Access Compliance Report

Public Rights-of-Way

(Curb Ramps)

Intersection ID: 45249	Main Street: CALDWELL_RD	Cross Street: FARMINGTON_RIDGE_PY	Location: E
ADA ID: B51883ED3818	Ramp Type: Directional1	Initial Pass/Fail: Fail	Overall Compliance: No
Severity Score: 1.25			
Codes/Mitigation Info/Possible Solution		Field Measurements/Component Compliance

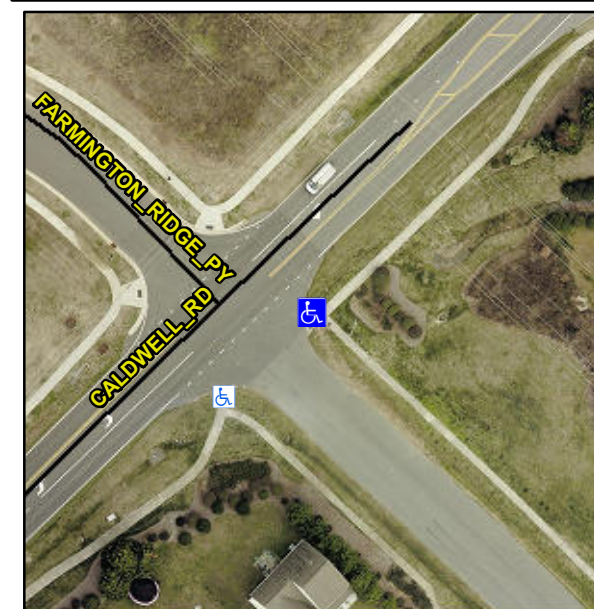
NO CURB

R304.5.3

Compliance	Description	Data	Compliance	Description	Data
N/A	Ramp Length (in)	93.0	N/A	Grade Break?	N/A
Yes	Ramp Width (in)	50.0	N/A	Grade Break Slope (%)	0.0
Yes	Ramp Slope (%)	6.8	N/A	Grade Break XSlope (%)	0.0
No	Ramp XSlope (%)	2.4			
N/A	Flare Type LT	N/A	N/A	Flare Type RT	N/A
N/A	Flare Slope LT (%)	N/A	N/A	Flare Slope RT (%)	0.0
N/A	Flare Traversable LT?	N/A	N/A	Flare Traversable RT?	N/A
N/A	Landing Length (in)	0.0	N/A	DWS Provided?	N/A
N/A	Landing Width (in)	0.0	N/A	DWS Contrast?	N/A
N/A	Landing Slope (%)	0.0	N/A	DWS Length (in)	N/A
N/A	Landing X Slope (%)	0.0	N/A	DWS Full Width?	N/A
N/A	Landing Curb? (Y/N)	N/A	N/A	DWS Offset LT (in)	N/A
N/A	Shared Landing?	N/A	N/A	DWS Offset RT (in)	N/A
N/A	Gutter Ponding?	0.0	N/A	Gutter Slope (%)	N/A
N/A	Gutter Lip Ht (in)	1.0	N/A	Gutter X Slope (%)	N/A
N/A	Painted X Walk1?	No		Road Slope (%)	4.6
	X Walk 1 Direction	To SW		Road X Slope (%)	0.5
	X Walk 1 Width (in)	N/A		Clear Space?	N/A

Remove & Replace Entire Ramp.
